**Oxley Solar Farm**

# **Amendment Report**

**November 2022**

**Project Number: 21-393**

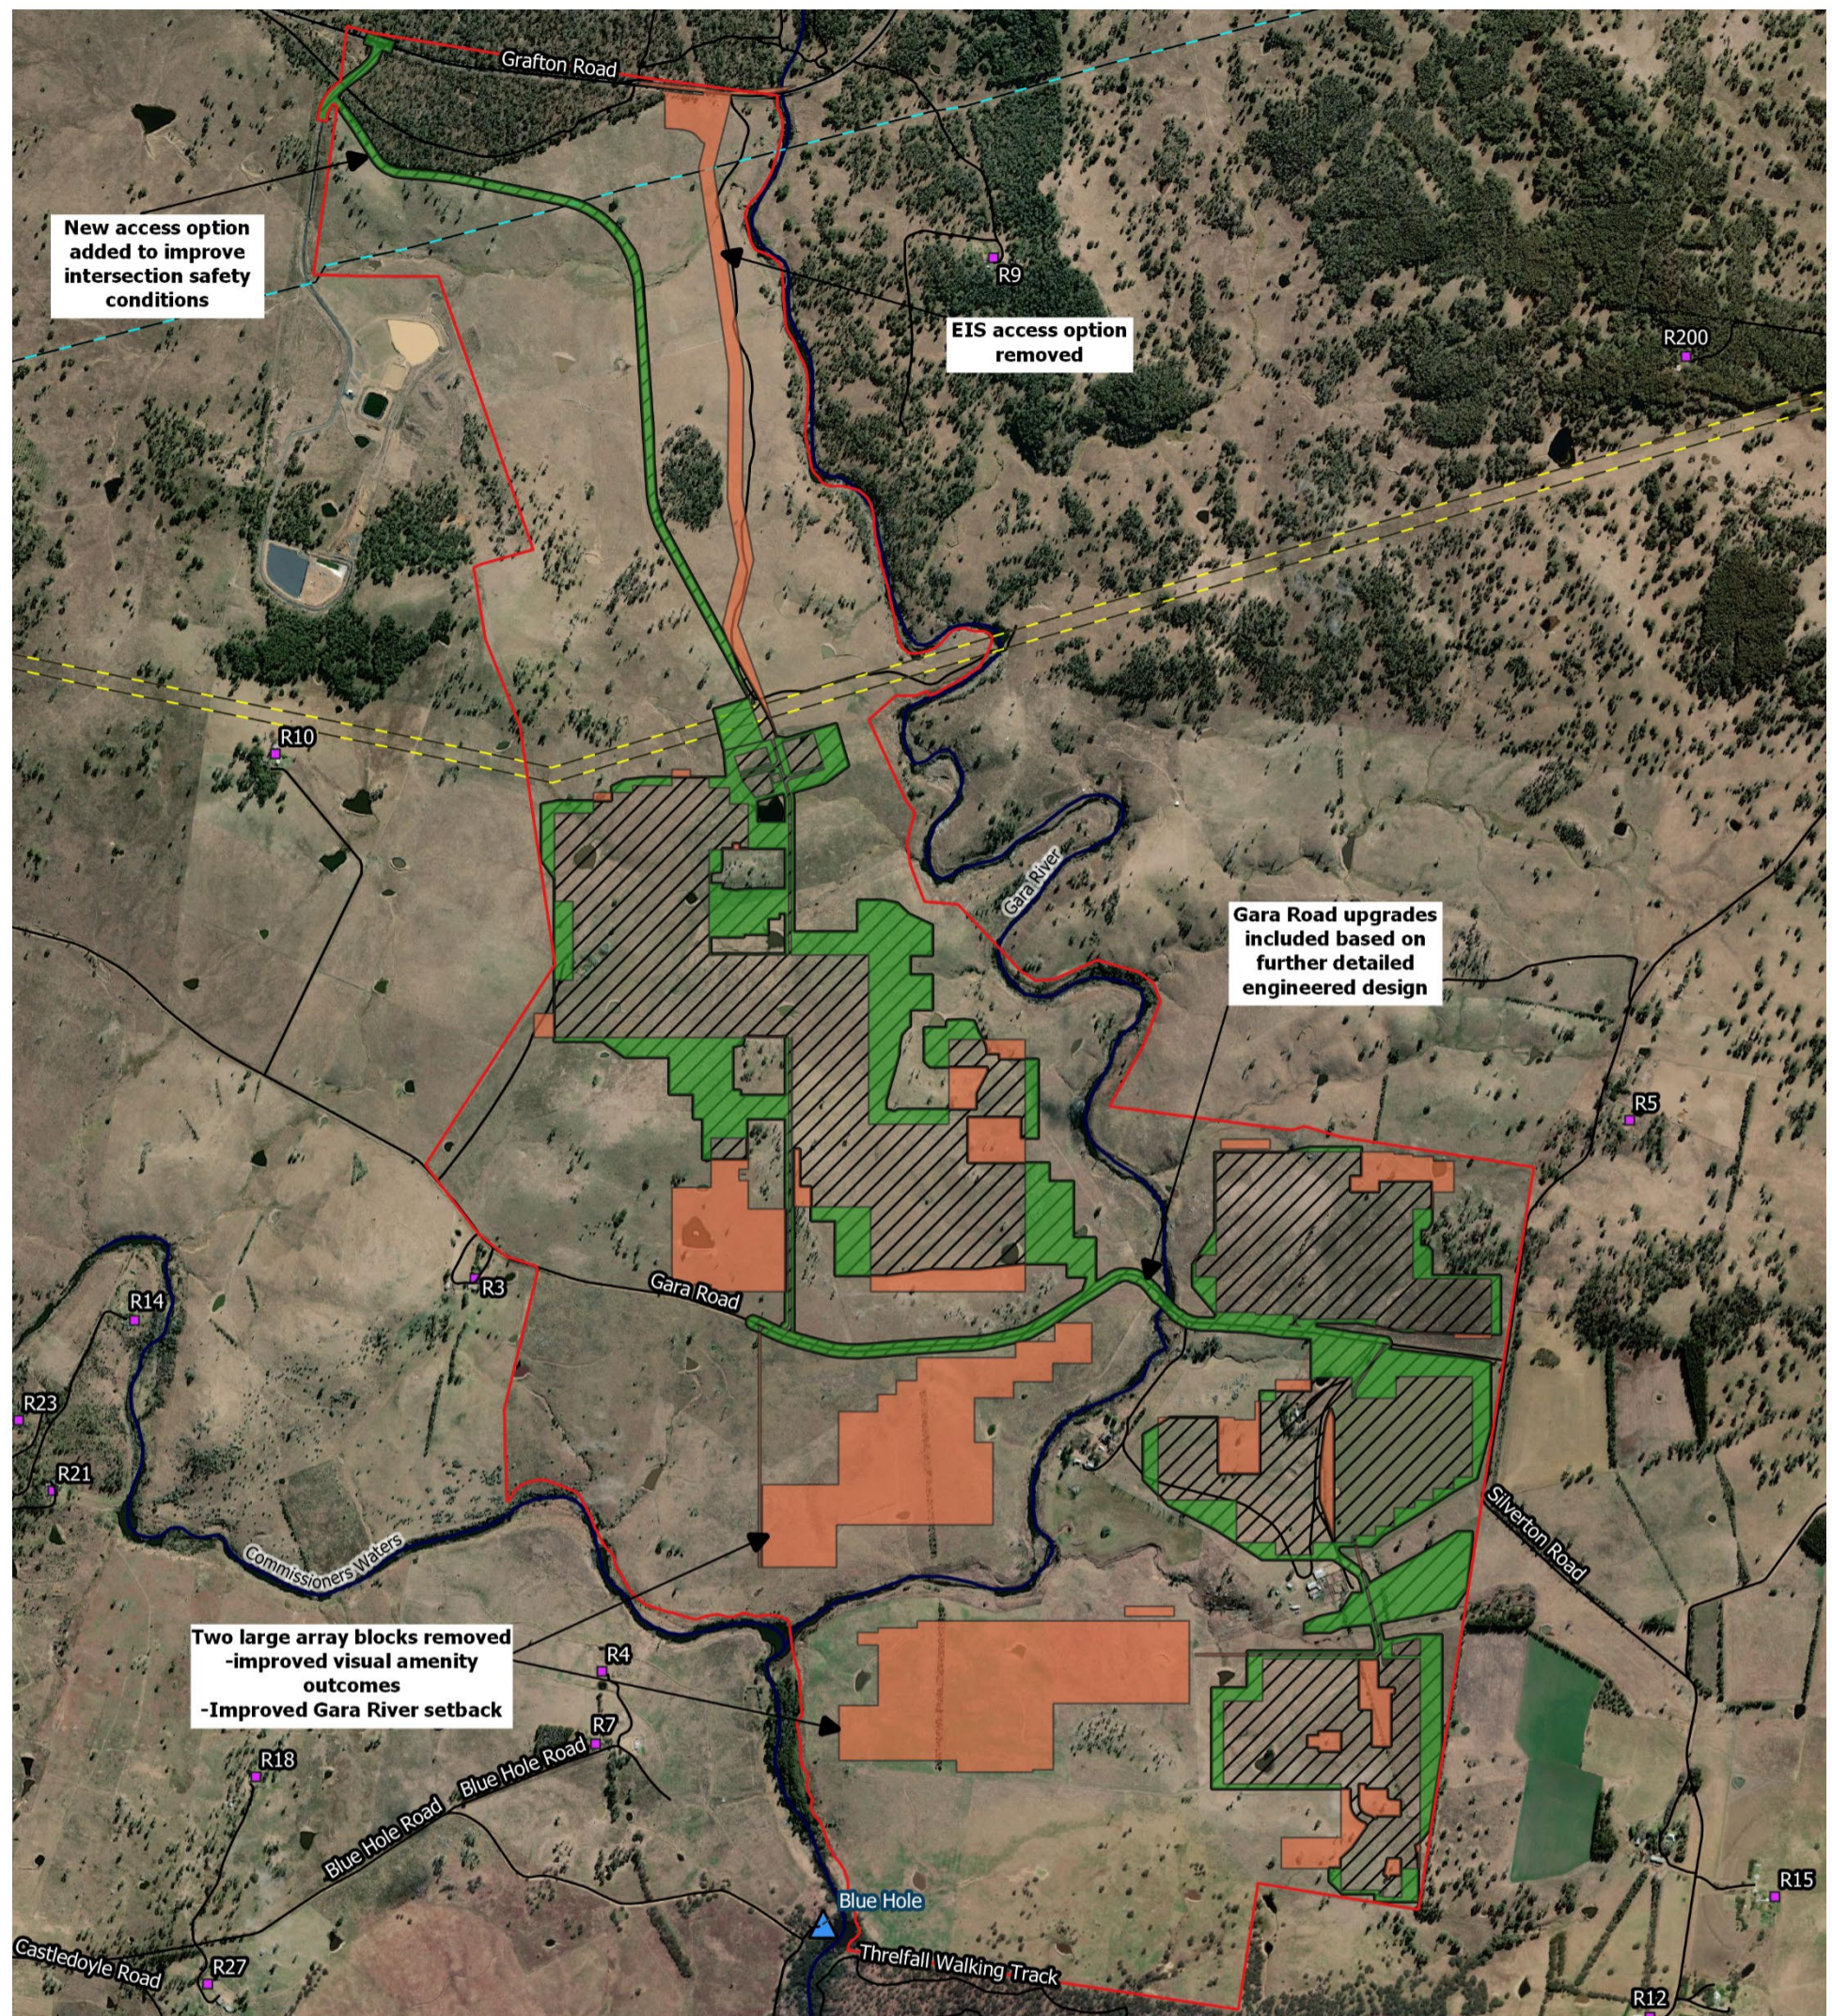
Scoping report	EIS Proposal	Amended Proposal	<i>Difference between EIS and Amended Proposal</i>
<b>Proposed infrastructure</b>				
Capacity of solar generation	Up to 300MW	255MW	<b>215MW</b>	<i>Reduced by 40MW</i>
Percentage generation capacity compared with Scoping Report	-	85%	72%	<i>Reduced by 13%</i>
Solar Panel Area (including access road)	380.66 ha	269.78ha	<b>195.25ha</b>	<i>Reduced by 74.5ha</i>
Percentage solar panel area compared with Scoping Report	-	71%	<b>51.29%</b>	
Number of solar panels	1,017,856	715,680	<b>385,280</b>	<i>Reduced by 330,400 panels</i>
Percentage solar panels compared with Scoping Report	-	70%	<b>38%</b>	
Development footprint area	-	895ha <sup>6</sup>	<b>268ha <sup>7</sup></b>	<i>Reduced by 627ha</i>
Percentage of Development footprint area compared with the			<b>70%</b>

Scoping report	EIS Proposal	Amended Proposal	<i>Difference between EIS and Amended Proposal</i>
EIS				
<b>Visual impact reductions</b>				
Distance of nearest above ground infrastructure to dwelling R3 (m) <sup>8</sup>	200	597	<b>778</b>	<i>Increased by 181m</i>
Distance of nearest above ground infrastructure to dwelling R4 (m)	400	570	<b>1,392</b>	<i>Increased by 822m</i>
Distance of nearest above ground infrastructure to dwelling R7 (m)	500	739	<b>1,584</b>	<i>Increased by 845m</i>
<b>Oxley Wild Rivers National Park</b>				
Distance of nearest infrastructure to the Blue Hole picnic table (m)	200	475	<b>1,285</b>	<i>Increased by 810m</i>
Distance of nearest infrastructure to the Threlfall walking track (m)	50	667	<b>1,165</b>	<i>Increased by 498m</i>

Figure 3-1 Comparison of changes made between the EIS's infrastructure layout and the now refined Development footprint.

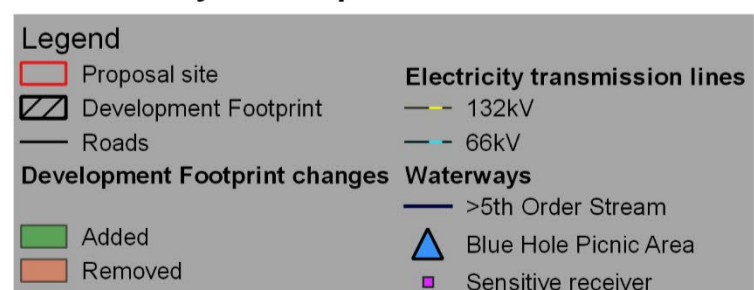
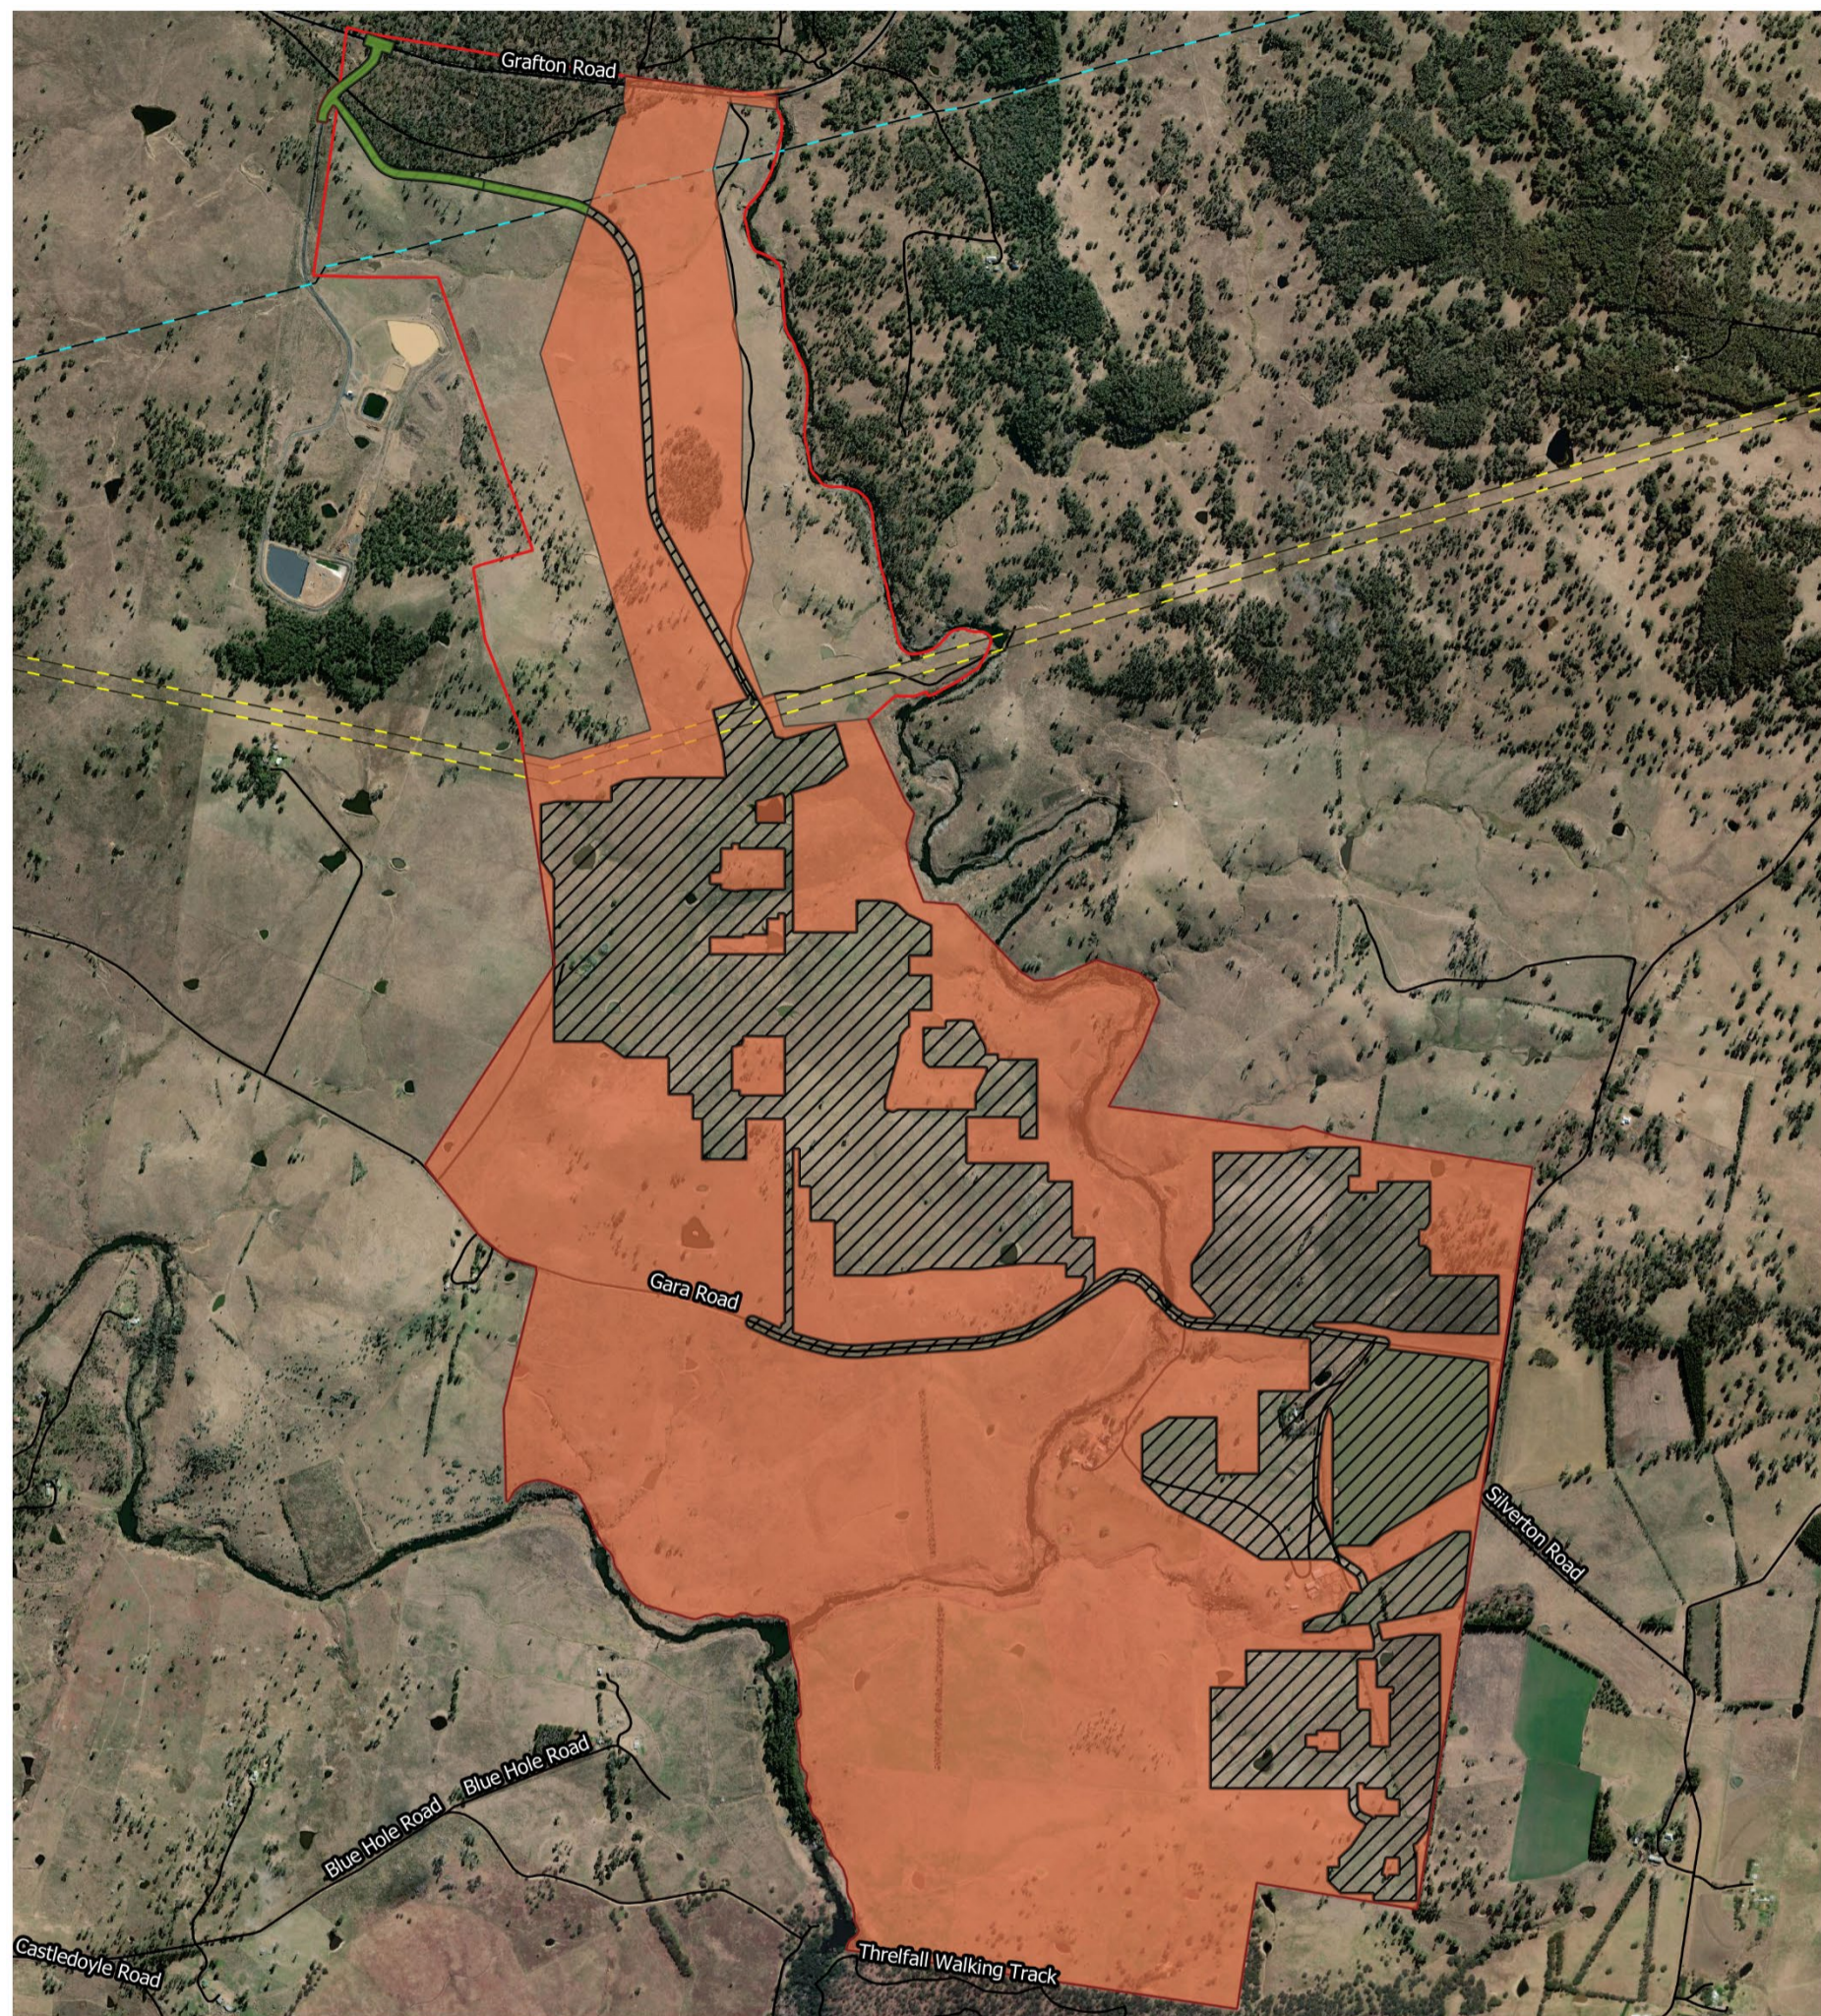
The changes detailed in full in Appendix A (an updated Proposal description) and shown in: Figure 3-1, Figure 3-2 and Figure 3-3.

The Development footprint area has reduced by 627ha and the solar panel area including access roads has reduced by 74.5ha. The overall reduction in the Proposal's capacity however, is not substantively affected (13% reduction; now 215MW). The key change has been to reduce temporary impact areas required for construction and include additional 'exclusion zones' to protect biodiversity and heritage areas.
